AMENDMENT 1

**Information technology – Implementation and operation of customer premises cabling –
Part 3: Testing of optical fibre cabling**

ISO/IEC 14763-3

Edition 1.0 2009-11

Figure 8 – Channel and permanent link test configuration

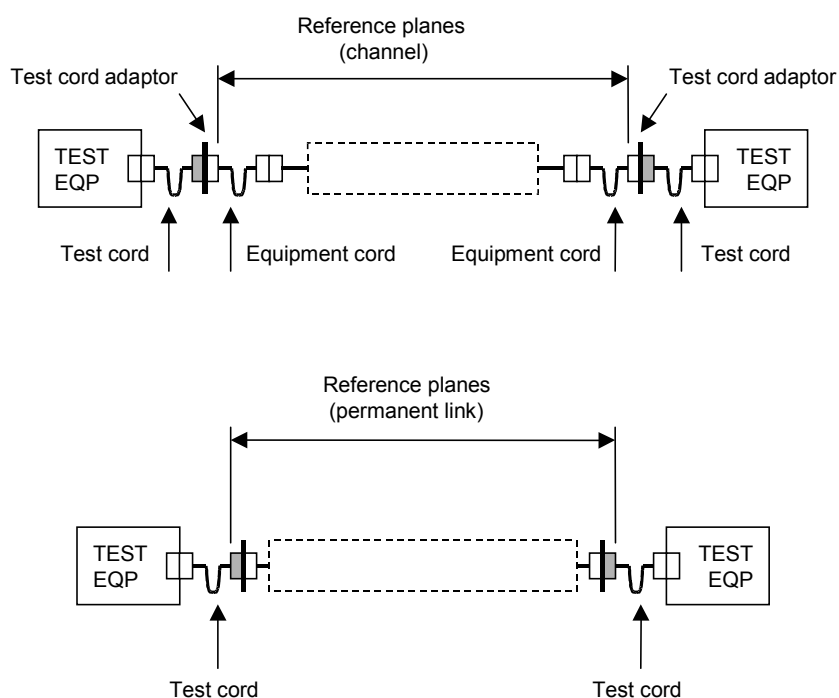
Replace the existing Figure 8 by the following new Figure 8:

NOTE The dotted area contains cable and may contain splices and additional connections.

The test configuration reference planes of a channel are within the equipment cords next to, but excluding, the connections of the equipment cords into the test cords (see Figure 8). The test configuration reference planes of a permanent link are within the test cords next to, and including, the test cord connections which mate to the termination points of the permanent link under test (see Figure 8).
